PROTEST- PETITION
This form may also be used for objections

**PETITION FOR TIME EXTENSION, CHANGE, TEMPORARY URGENT CHANGE OR
TRANSFER ON**

APPLICATION ____ **PERMIT** DWR permits 16478, 16479, 16481, 16482 and
Reclamation permits 11315, 11316, 12721, 12722, 12723, 11967, 11968, 11969, 11971,
11973, and 12364

Re: Proposed Changes to the Bay Delta Conservation Plan/California WaterFix Continue to Threaten the Delta, Time for Plan "B"

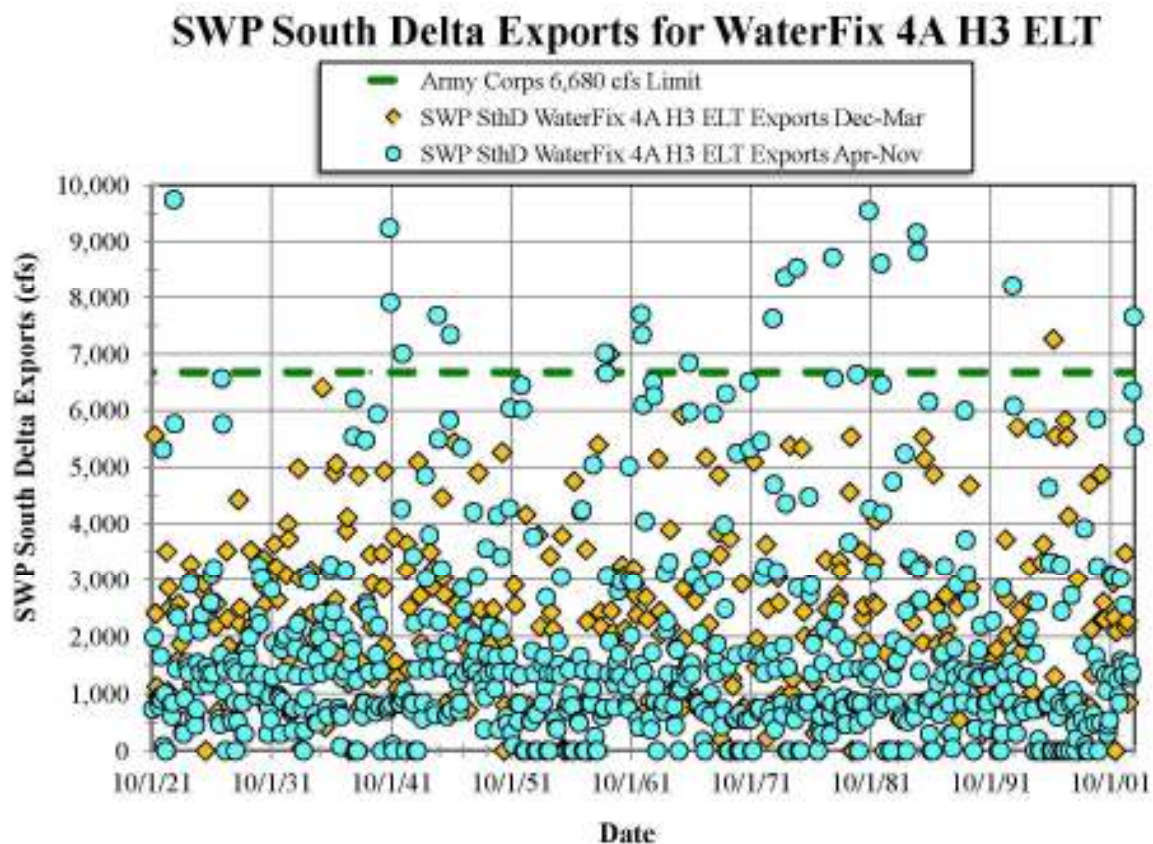
Figure C-5 shows the WaterFix analysis SWP South Delta export data for Alternative 4A, Scenario H3, at early long term, for April through November when the Army Corps limits of 6,680 cfs apply. The simulated inflows to Clifton Court (SWP through-Delta exports) are as high as 9,750 cfs with total south Delta export as high as 14,350 cfs. This is well in excess of the permitted values for this period, and is inconsistent with the WaterFix project claim of ecosystem benefits because exports from the south Delta will be reduced.

The WaterFix RDEIR/SDEIS is inadequate because it fails to clearly disclose to the public and to decision makers like the Army Corps that DWR is proposing to eliminate existing limits on the inflow to Clifton Court, and that the analyses to support the Army Corps application violates that limit.

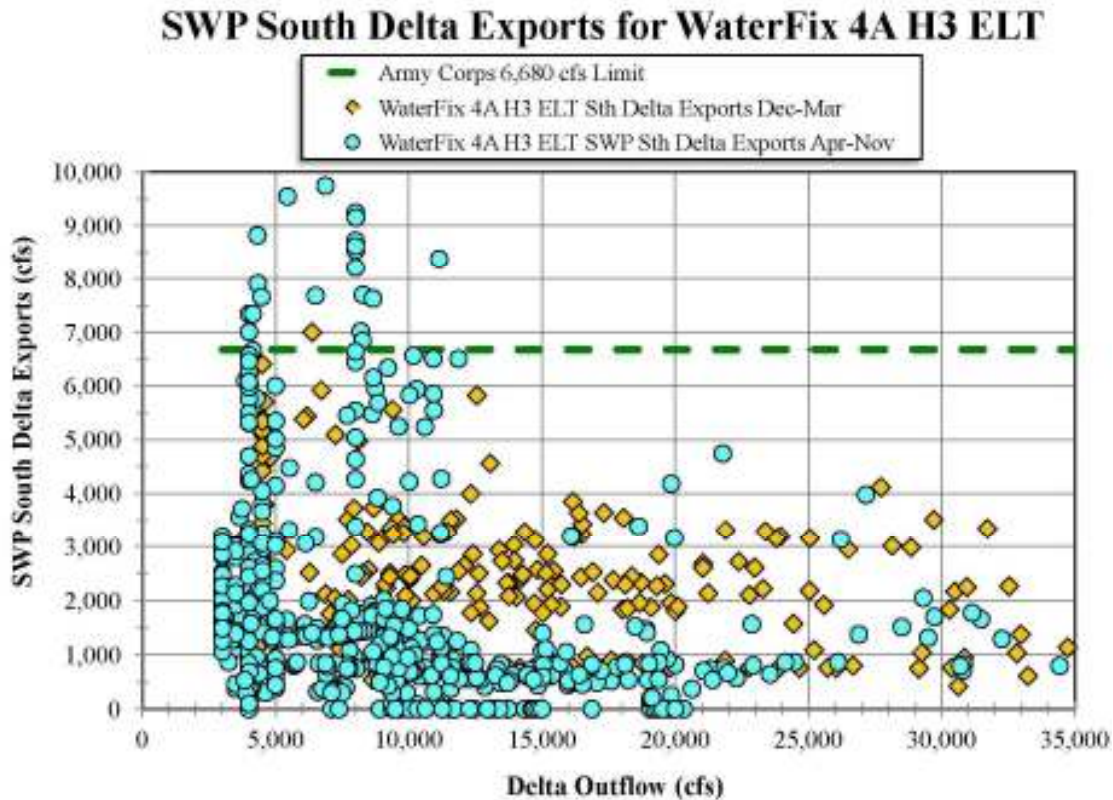
Figure C-6 shows the same SWP south Delta export data as Figure C-5, but this time plotted as a function of Delta outflow. The violations of the Army Corps limits occur during drier months when Delta outflows are lower. This is again directly contrary to the principle of taking a “Little Sip” during drier periods, *i.e.*, reducing exports relative to existing levels.

During high outflow periods (outflows > 15,000 cfs), inflows to Clifton Court are well below the maximum permitted inflow.

A new Draft EIR/EIS must be prepared that includes new alternatives that comply with the U.S. Army Corps of Engineers limits on inflow to Clifton Court Forebay, and other legal requirements set by the SWRCB and the biological opinion, and released for public review and comment.

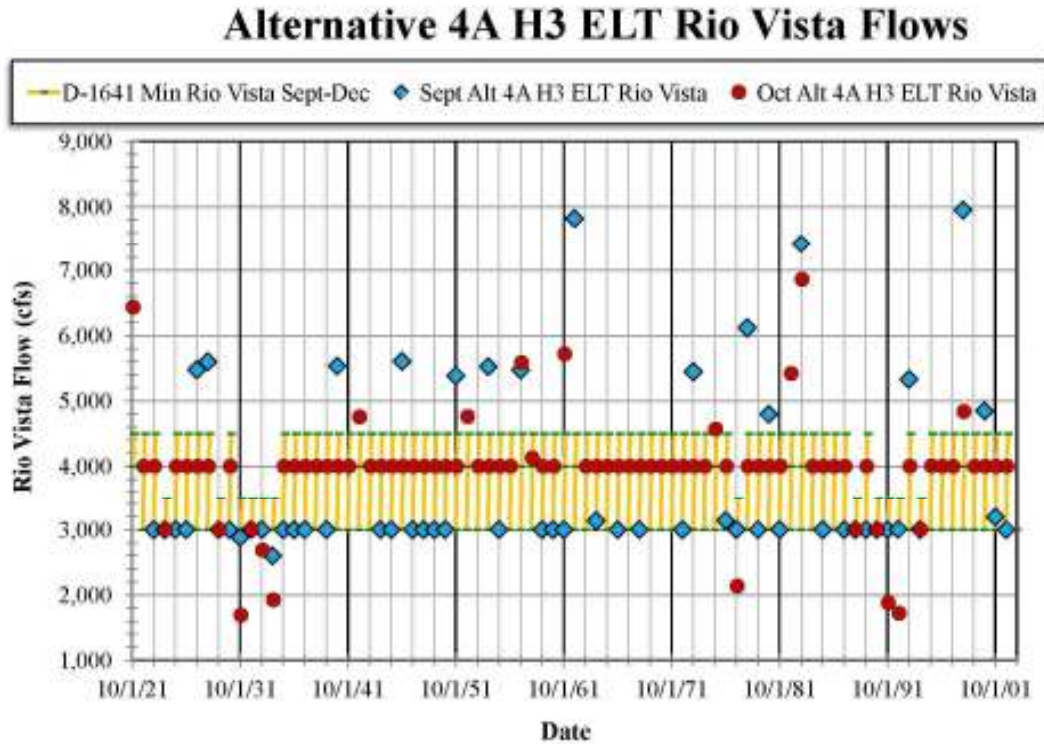
SWRCB Water Rights Decision 1641 requires minimum Rio Vista flows be met in the fall (September through December). As shown in Figure C-7, the monthly Rio Vista flows for September and October for the WaterFix preferred alternative (Alternative 4A, Scenario H3 at Early Long Term) fall well below the D-1641 requirements in a number of the drier years.

DWR and Reclamation's change of point of diversion petition to the SWRCB for the WaterFix project also fails to disclose to the SWRCB that the WaterFix proponents are either proposing to

selectively ignore certain D-1641 standards or that the analyses used to support the petition are flawed and not acceptable for decision making.

The WaterFix RDEIR/SDEIS is inadequate because it fails to comply with the SWRCB minimum flow requirements at Rio Vista and fails to clearly disclose these significant violations to decision makers and the public. A new Draft EIR/EIS must be prepared which includes new alternatives that comply with all legal requirements including the Rio Vista minimum flow standards and then be released for public review and comment.

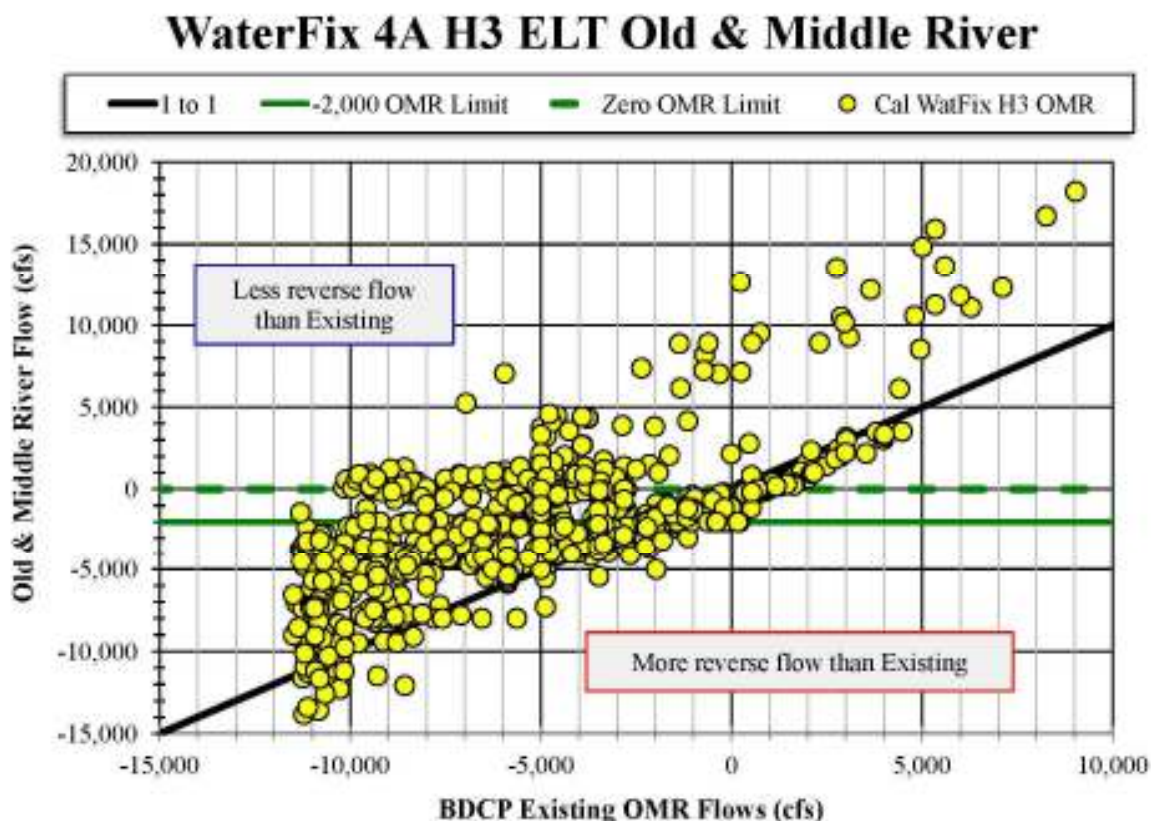
Figure C-8 shows simulated monthly Old and Middle River flows for the WaterFix preferred alternative (Alternative 4A, Scenario H3 at Early Long Term) compared to the OMR flows for the existing basecase, as a scatter plot. Many of the monthly reverse flows are very large in the base case (x-axis) and would remain large even with implementation of the WaterFix preferred alternative with its new north Delta intakes. Some of the existing large reverse flows would get even worse with WaterFix. OMR values of -12,000 cfs in the basecase would worsen to -14,000 cfs and harm resident fish in the Delta. The published claims that the RDEIR/SDEIS and the proposed project will minimize reverse flows are untrue, and could be viewed as disingenuous.

By claiming the north Delta intakes benefit fish by minimizing reverse flows, the BDCP and WaterFix proponents are acknowledging the current level of exports from the south Delta exports adversely impact fish species. For a proposed Bay-Delta project to be able to contribute to meeting the coequal goals and help restore and sustain fish species, the project operating rules will need to effectively eliminate reverse flows in the critical months for the key fish species, but also significantly decrease (not increase) reverse flows in the south Delta in all the other months.

The WaterFix project and RDEIR/SDEIS is inadequate because it fails to minimize reverse flows in the Delta, and fails to clearly disclose these significant adverse impacts on fish in the Delta. A new Draft EIR/EIS must be prepared which includes new alternatives that significantly reduce or eliminate reverse flows and be released for public review and comment.

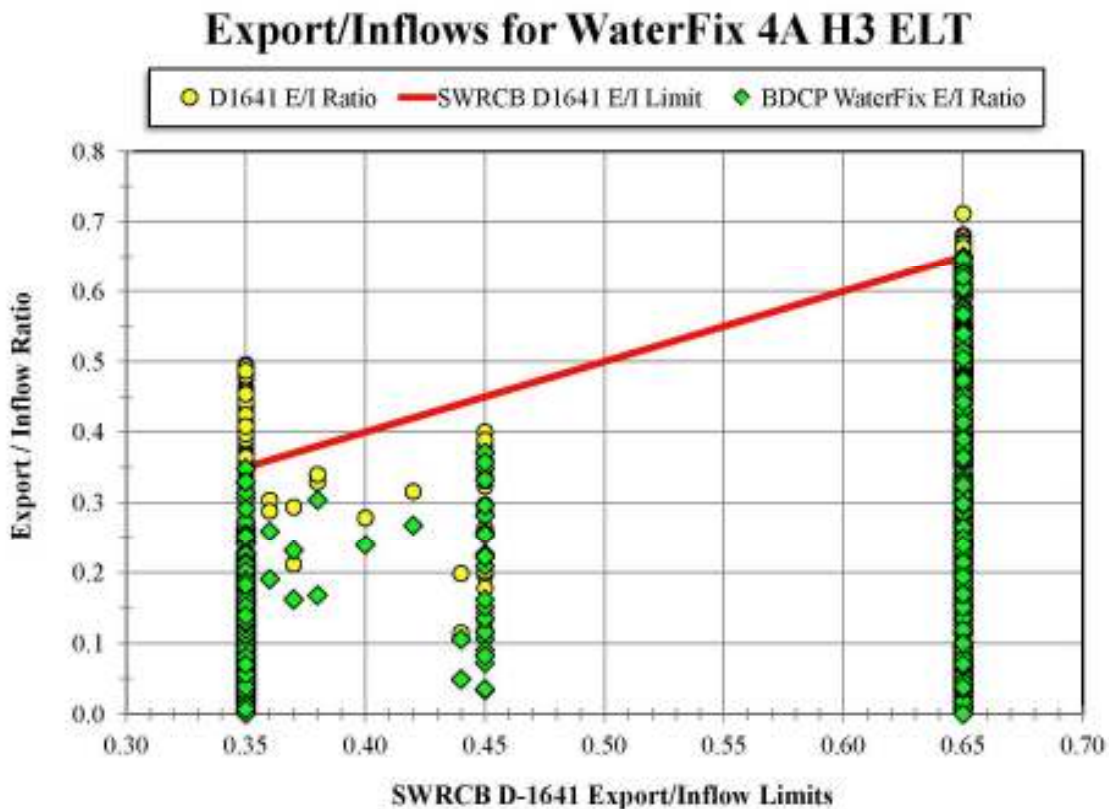
Figure C-9 shows the RDEIR/SDEIS simulations of monthly export/inflow ratios for the WaterFix preferred alternative (Alternative 4A, Scenario H3 at Early Long Term). The export ratios are computed according to the correct SWRCB Water Rights Decision 1641 definition (yellow circles), as well as the faulty definition used in the RDEIR/SDEIS (green diamonds). During periods when the export/inflow is required by D-1641 to be 0.35 or less, the WaterFix project would export almost 50% more water than permitted (E/I as much as 0.5). During periods when an export/inflow ratio of 0.65 is required under D-1641, the WaterFix preferred alternative E/I ratio is as high as 0.71.

A new Draft EIR/EIS must be prepared that analyze alternatives that comply with the SWRCB's export/inflow standards as well as the existing Army Corps limits on inflow to Clifton Court and the San Joaquin inflow to export ratios in the biological opinions. Additional full model runs could still be included to disclose individual impacts to the Delta ecosystem and water quality if

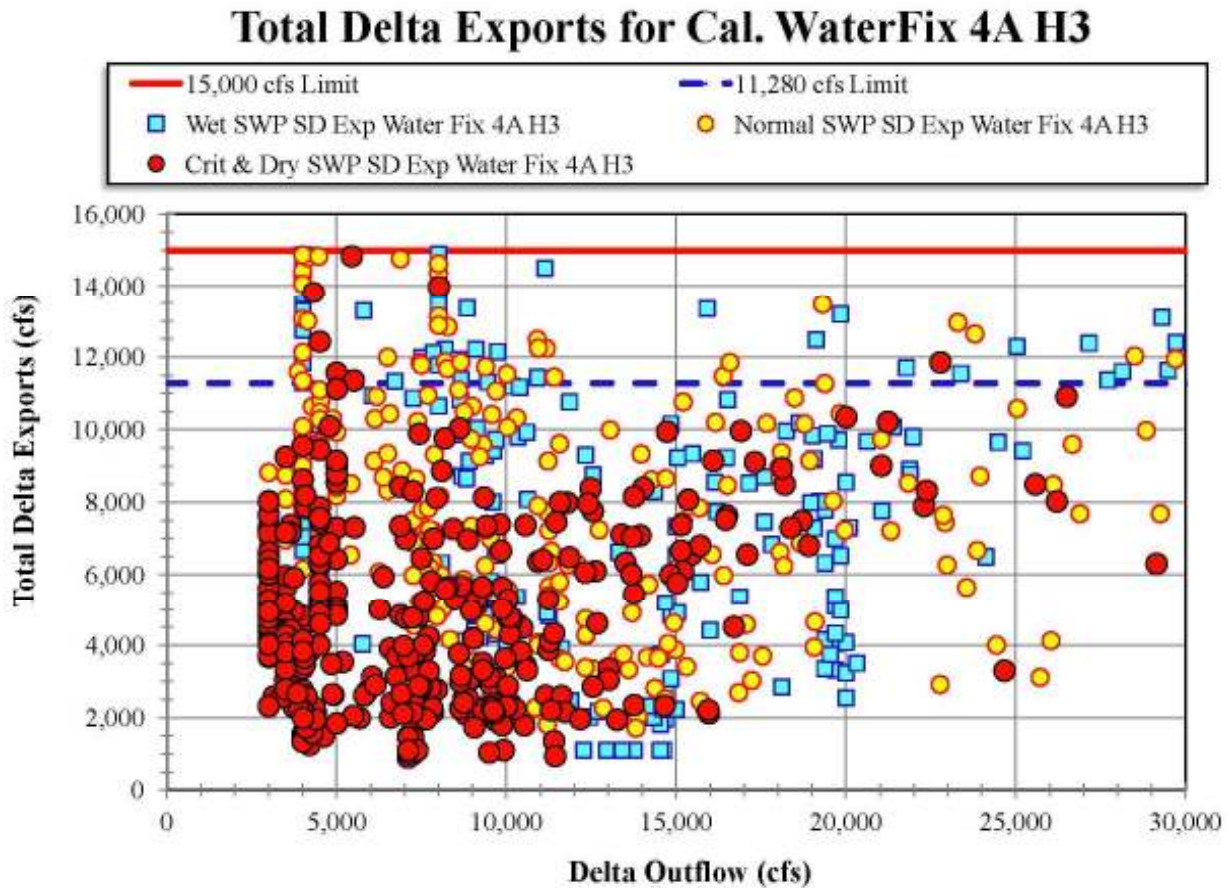
The Cal. WaterFix would not advance the State's water supply goals by improving the ability to capture water during wet years ("Big Gulp") and store it for use during dry years. The key to improving California's water supply is to be able to opportunistically capture water when it is available, i.e., during periods of high, surplus flow in the Delta and upstream of the upstream reservoirs. The focus should be on weeks and months rather than years. Unfortunately, the proposed project fails to capture any significant surplus flow during wet months because it does not include any new storage. Instead it relies on increasing exports from the Delta during dry

months when Delta outflows are very low (Figure 1, below), i.e., by taking advantage of the increase in maximum export capacity from 11,280 cfs under typical flow conditions and the existing Delta infrastructure, to 15,000 cfs with the proposed 9,000 cfs twin tunnels. This is contrary to the 2009 Delta Reform Act (Water Code section 85021) and threatens already stressed fish species.

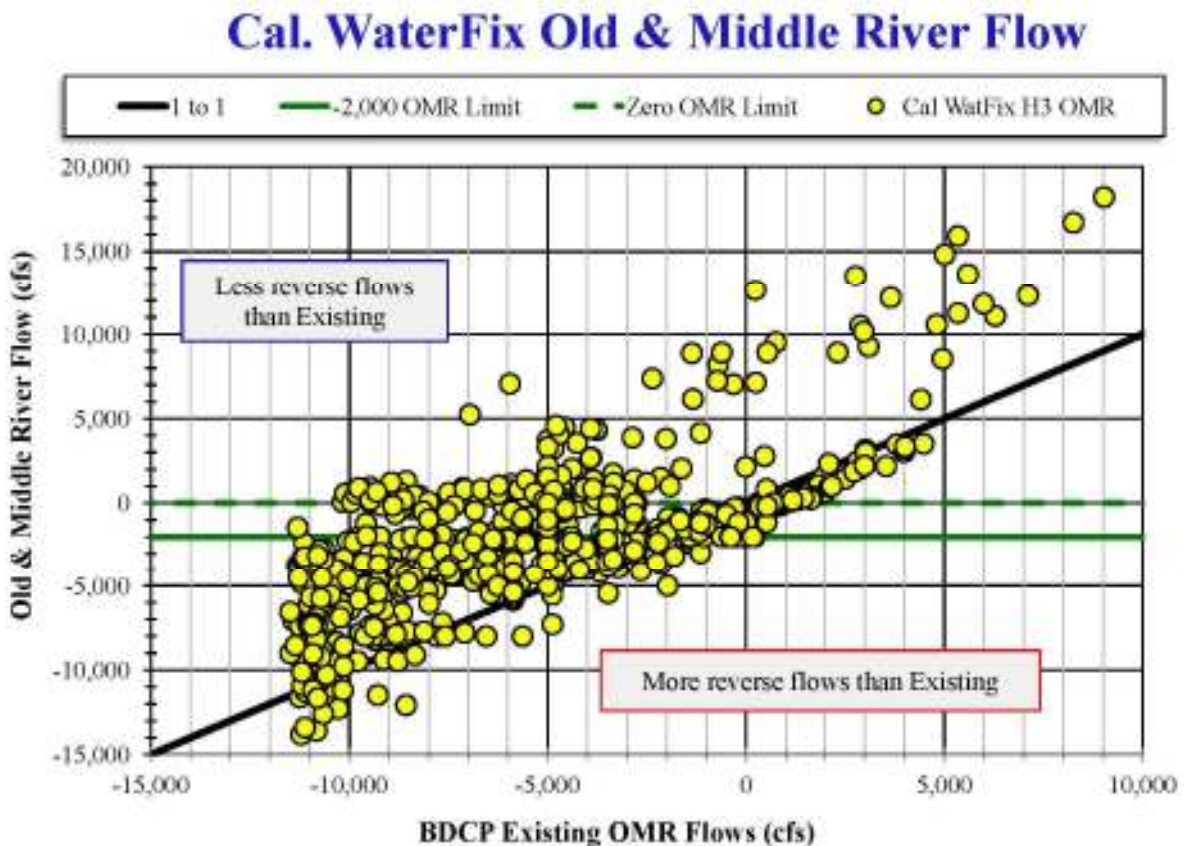
DWR and Reclamation suggest that their proposal “*would minimize environmental impacts commonly associated with the SWP and CVP*” by addressing the real problem of reverse flows in the south Delta (pages 4 and 5 of the supplemental information). However, the operating rules of

the WaterFix preferred alternative and continued use of the south Delta export intakes for half of the SWP and CVP alternatives does not minimize reverse flows in the south Delta (see Figure 2 below). Fish are resident in the Delta year round. Salvage of other species such as Striped bass, largemouth bass, white cat fish and Mississippi silversides are already large under existing conditions (see Grimaldo et al., “Factors affecting fish entrainment”). This is also likely to be a problem for sturgeon¹. The WaterFix project sets OMR limits for some of the year and will redirect impacts to July, August, September and October. Fish that are resident in the Delta year round may not be declining now, but they will if that period is subjected to increased reverse flows because of the WaterFix project.
